**Judson Rd. Water Infrastructure Improvement Project**  
**Solicitation Number: CO-00289-FG**  
**Job No.: 19-7002**

**ADDENDUM #2**  
**October 30, 2020**

JUDSON RD. WATER INFRASTRUCTURE IMPROVEMENTS  
**FORCE MAIN LAYOUT P & P**  
STA 34+70 TO STA 38+00  
SHEET 7 OF 11

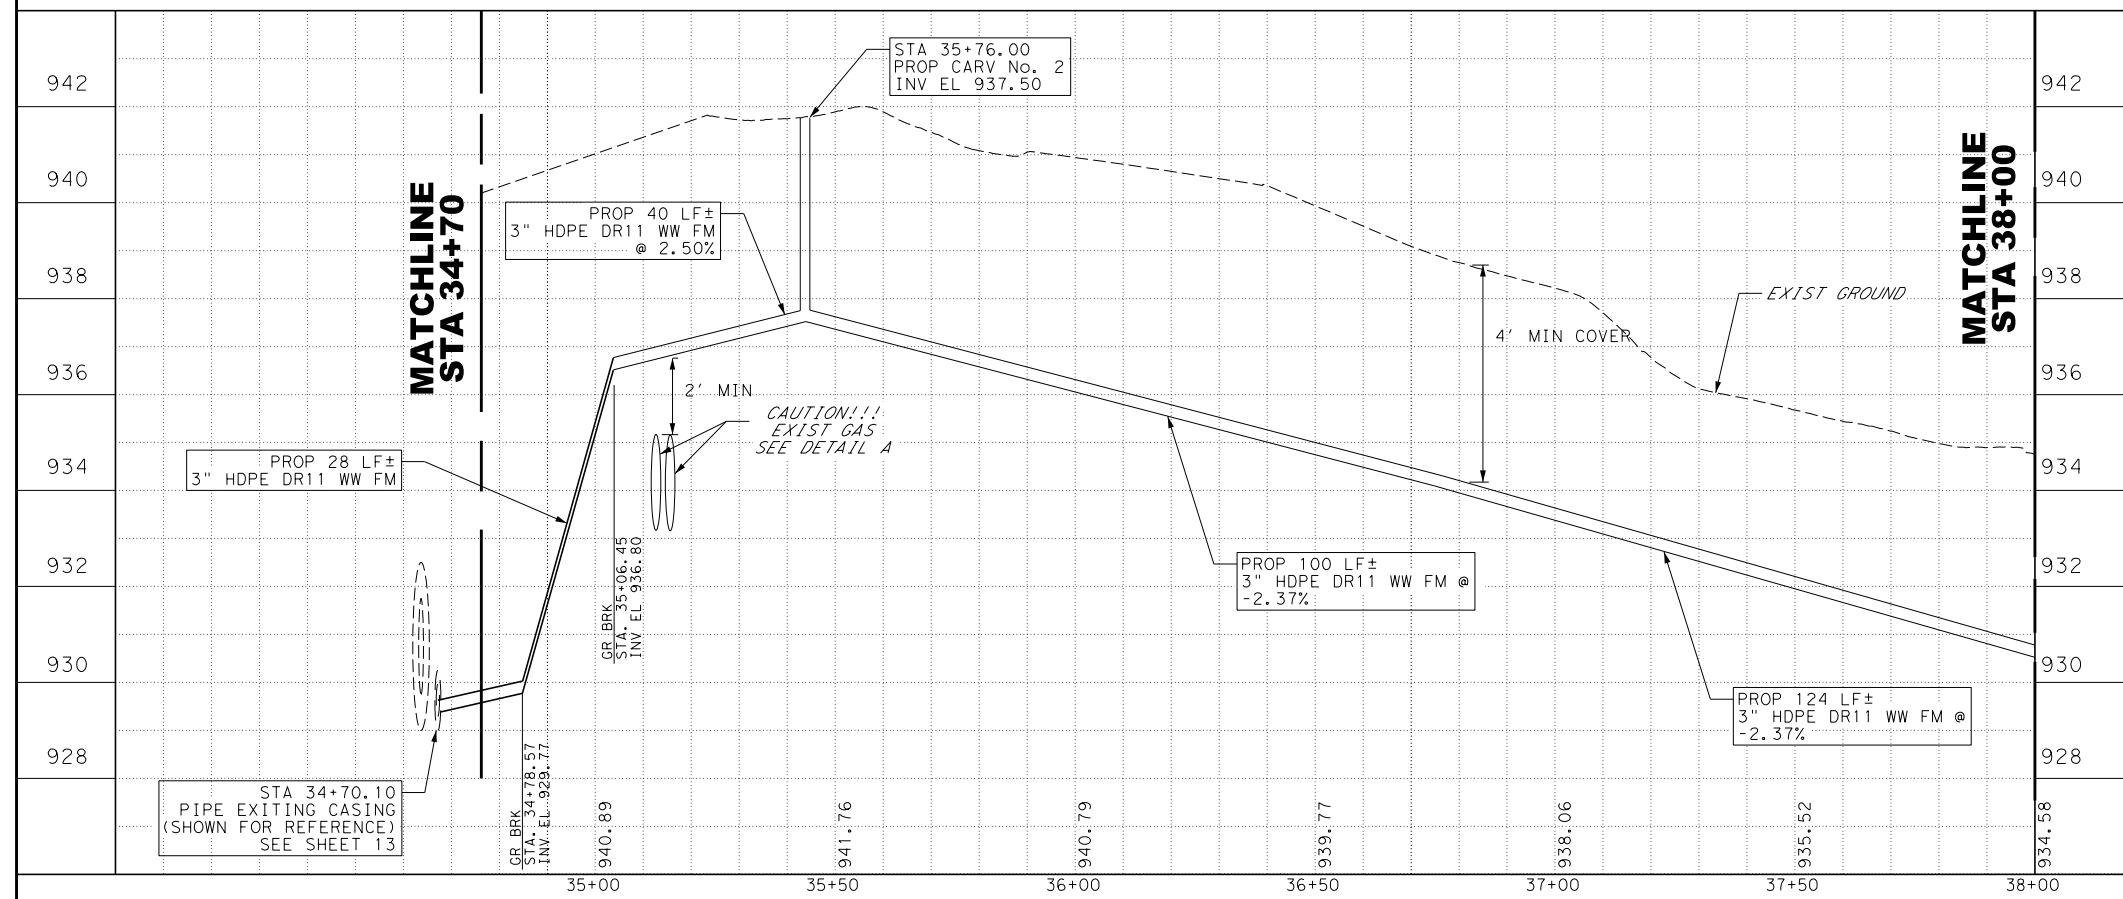
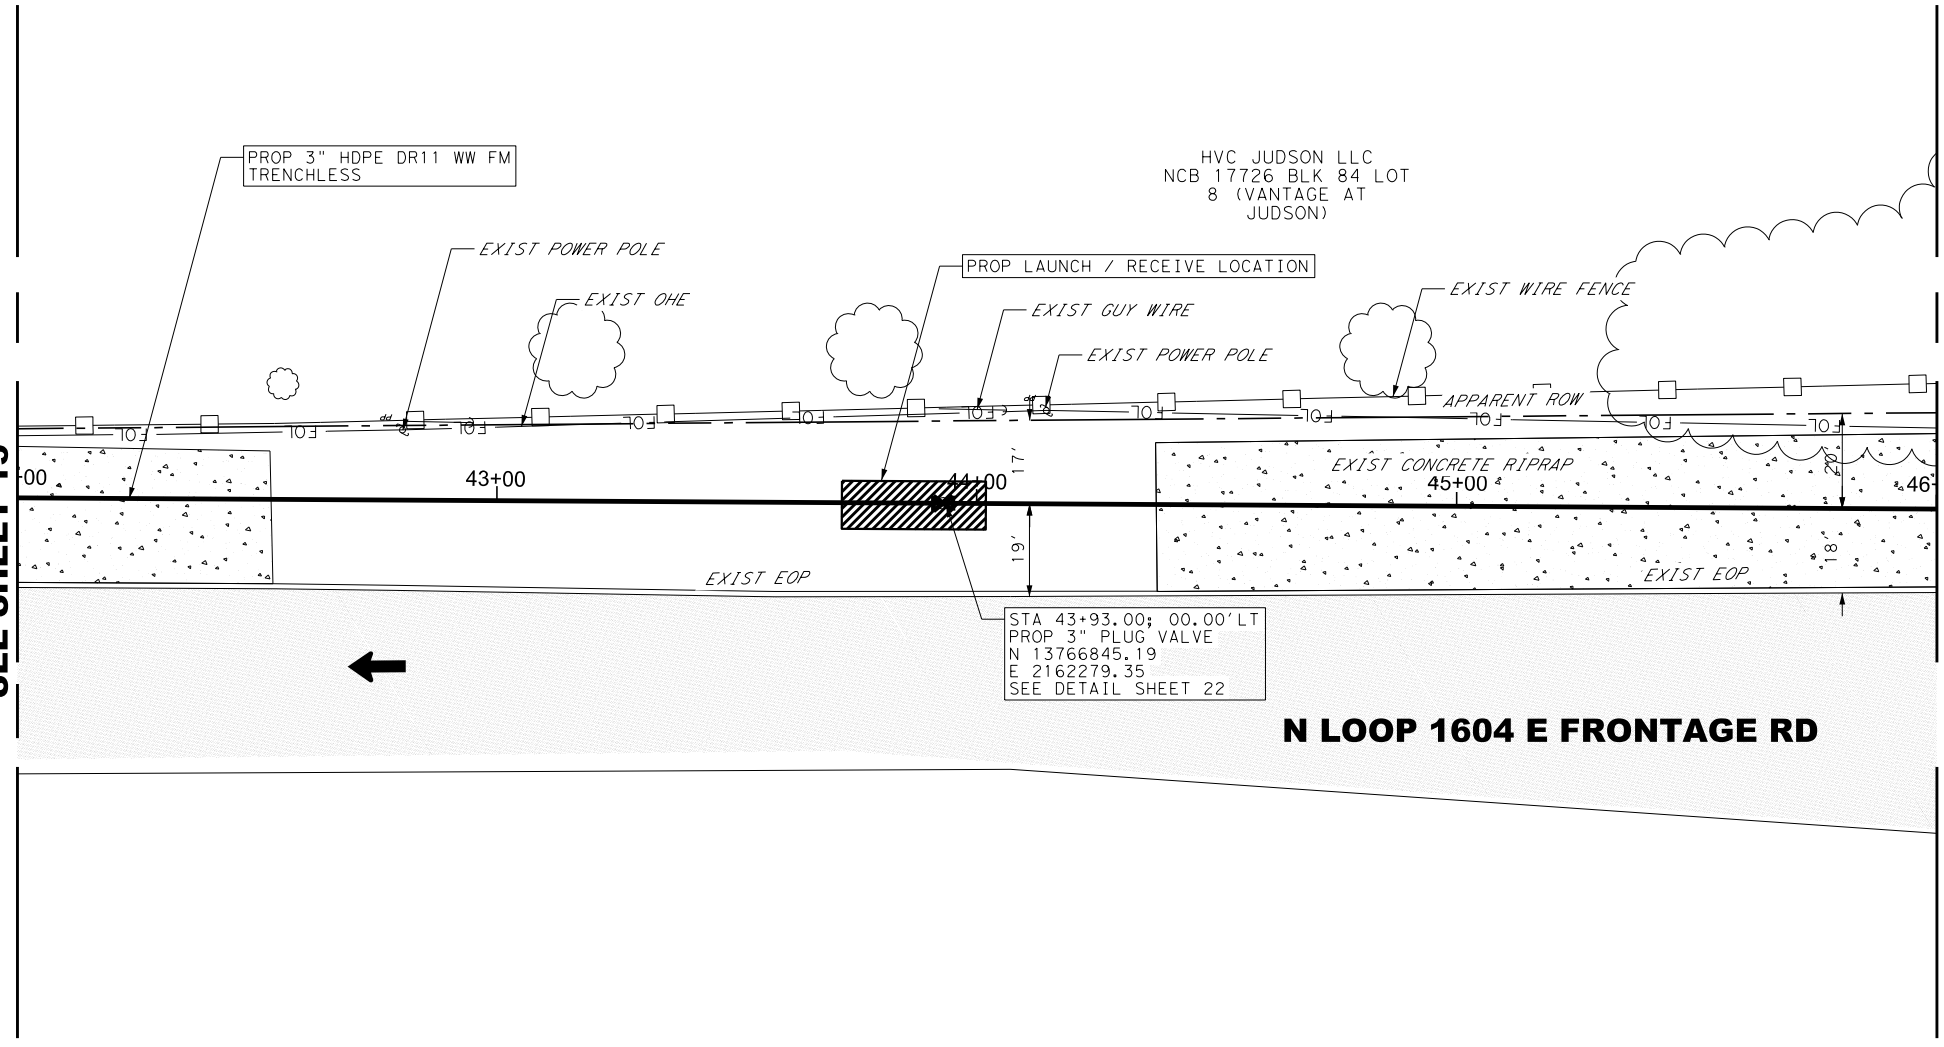
*Removed Two Way Sanitary Sewer Cleanout (3" Pressure) STA 36+76.00.  
Updated Sheet Quantity Table*

**JUDSON RD. WATER INFRASTRUCTURE IMPROVEMENTS**  
**FORCE MAIN LAYOUT P & P**  
**STA 42+00 TO STA 46+00**  
**SHEET 9 OF 11**

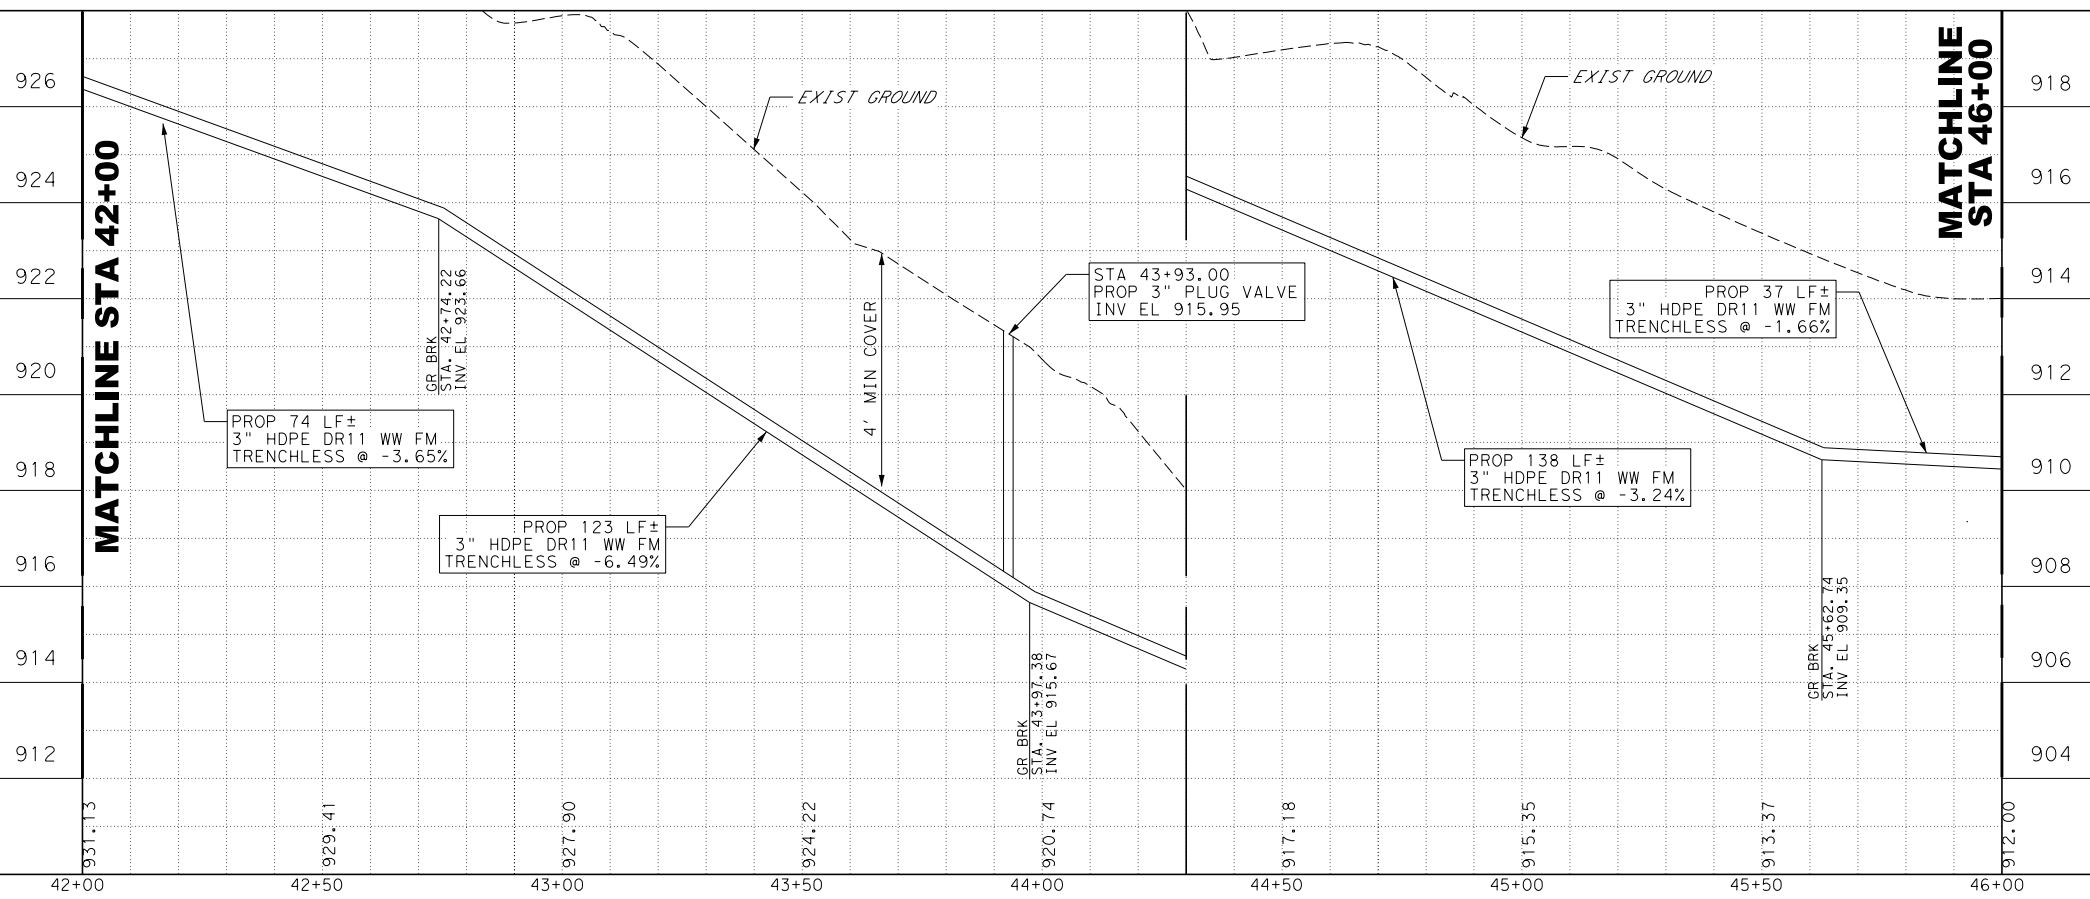
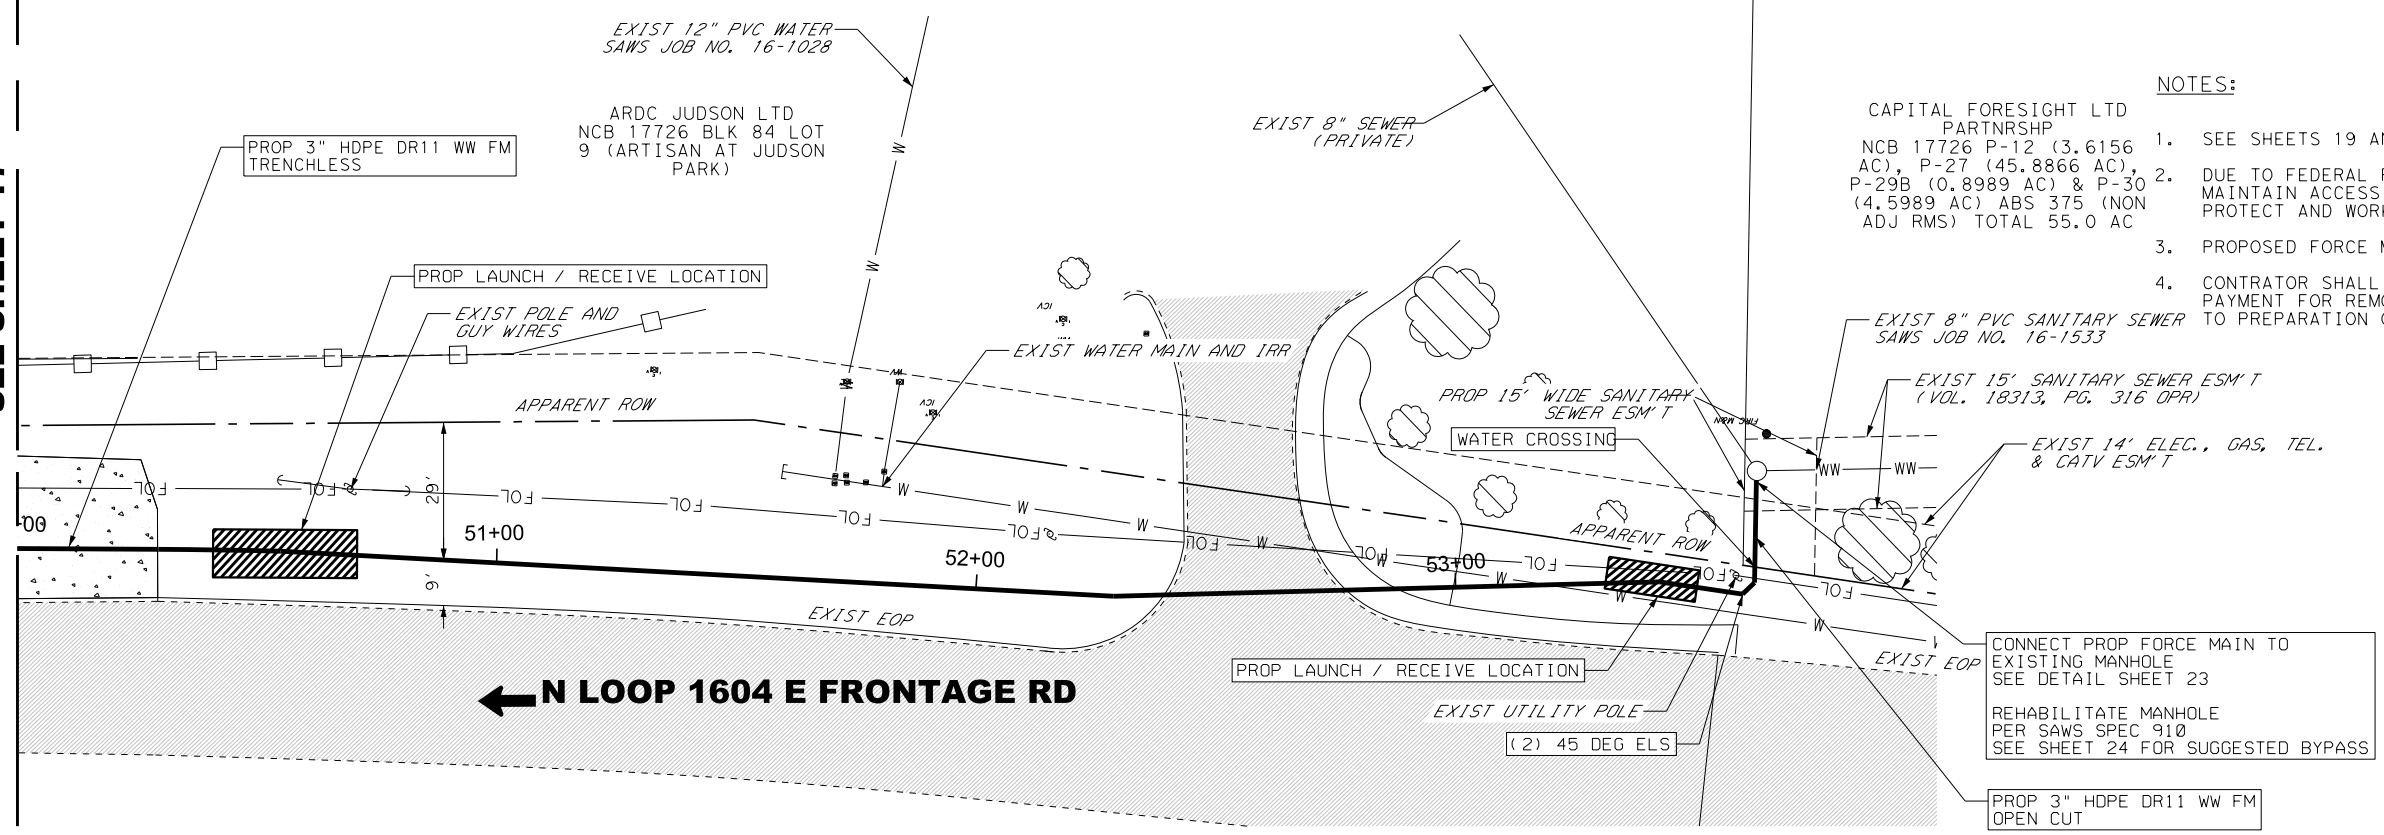
*Removed Two Way Sanitary Sewer Cleanout (3" Pressure) STA 43+80.00.  
Updated Sheet Quantity Table*

JUDSON RD. WATER INFRASTRUCTURE IMPROVEMENTS  
**FORCE MAIN LAYOUT P & P**  
STA 50+00 TO END  
SHEET 11 OF 11

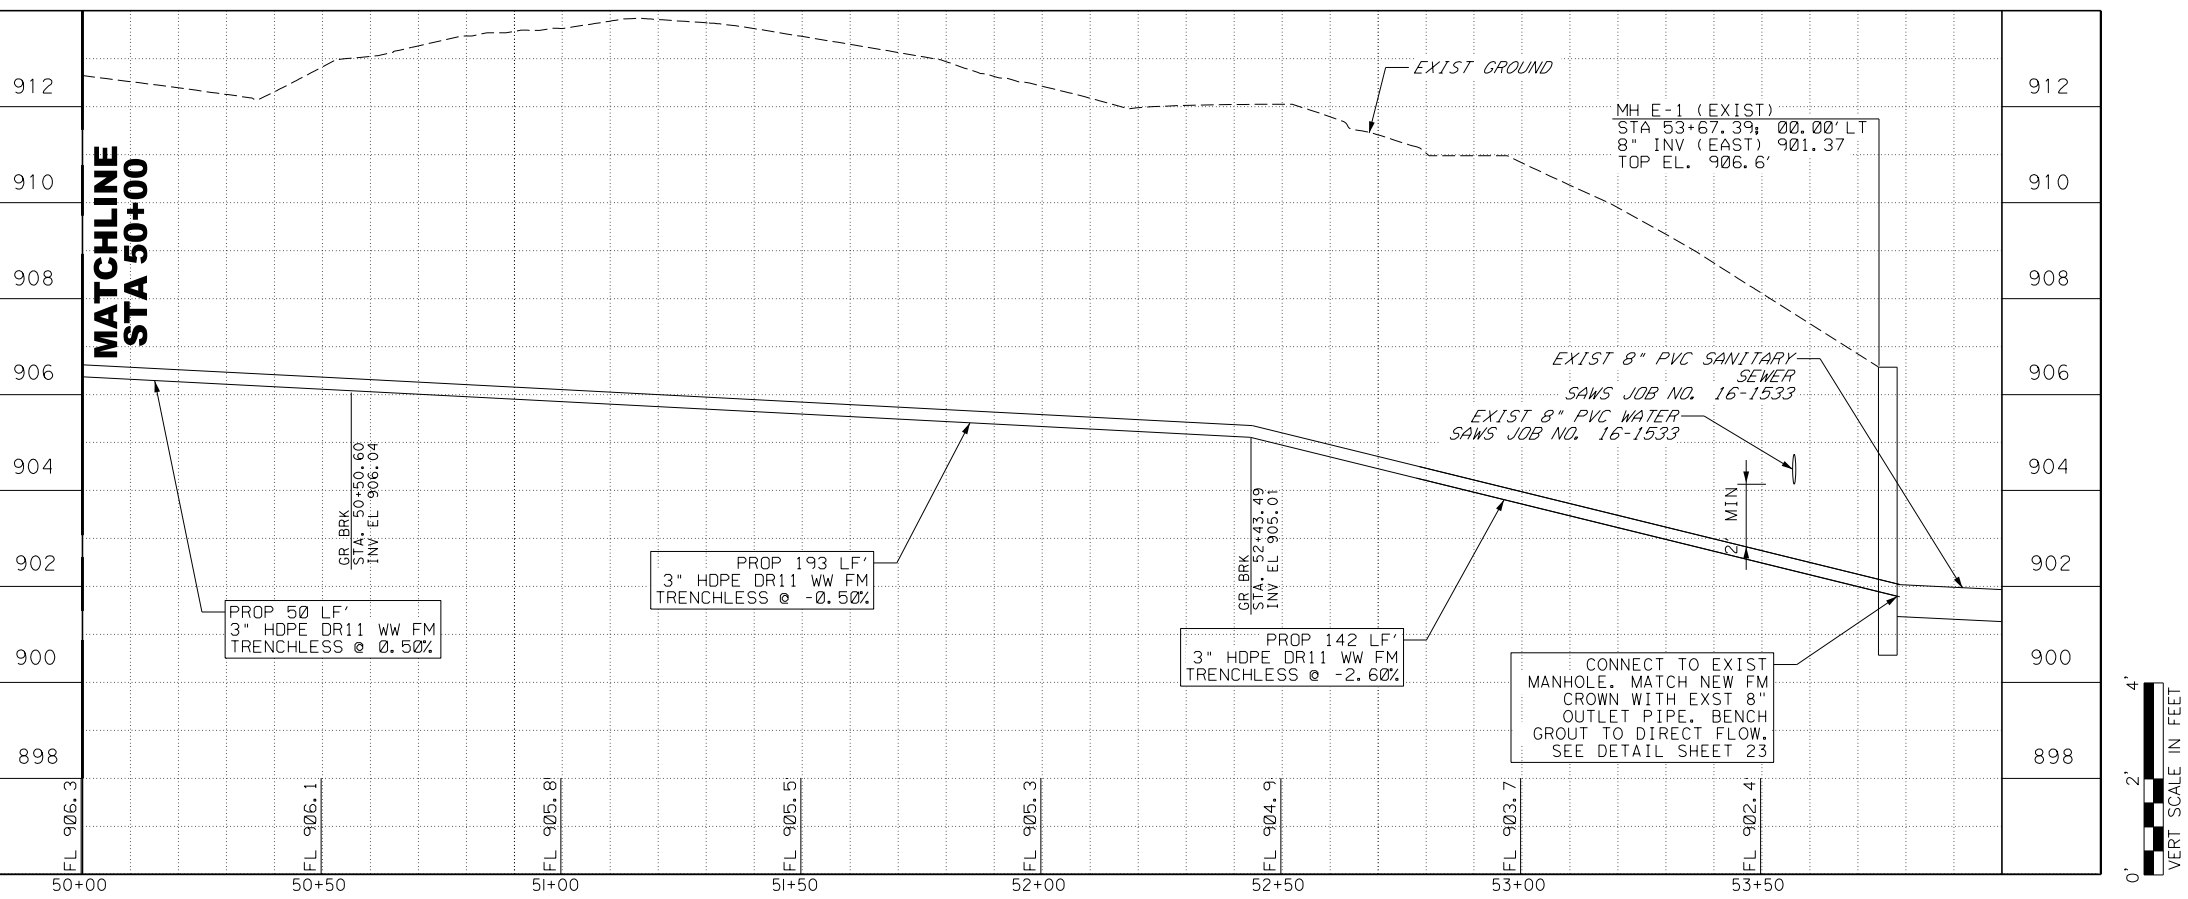
*Removed Two Way Sanitary Sewer Cleanout (3" Pressure) STA 50+50.60.  
Updated Sheet Quantity Table*

IN-LINE CLEANOUT - FORCE MAIN 3" DIA OR GREATER

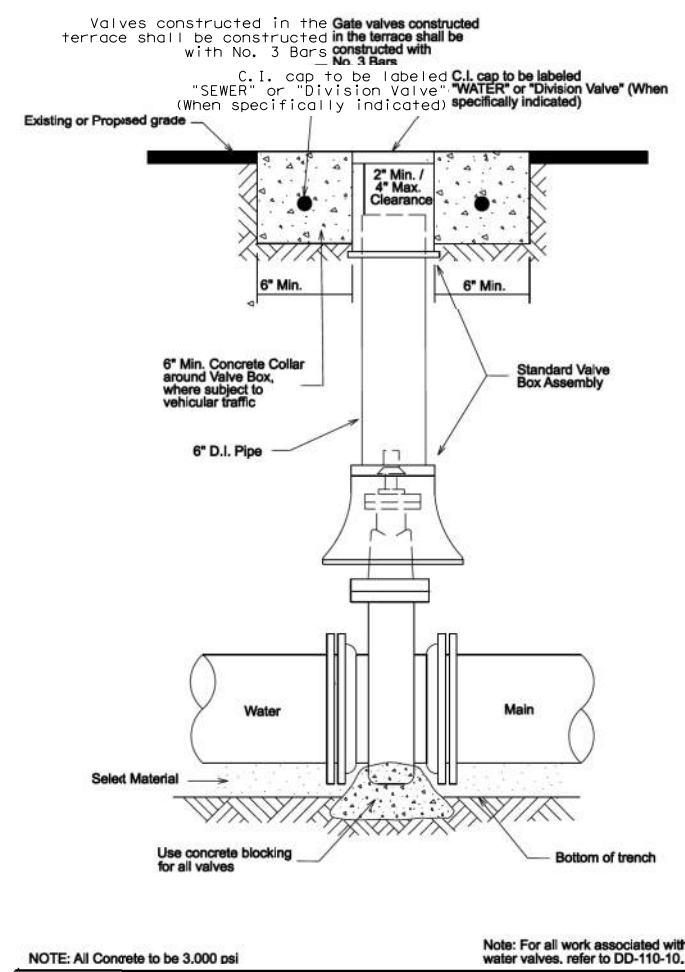
*Removed In-Line Cleanout – Force Main 3" DIA or Greater Detail).  
Updated Sheet Quantity Table*
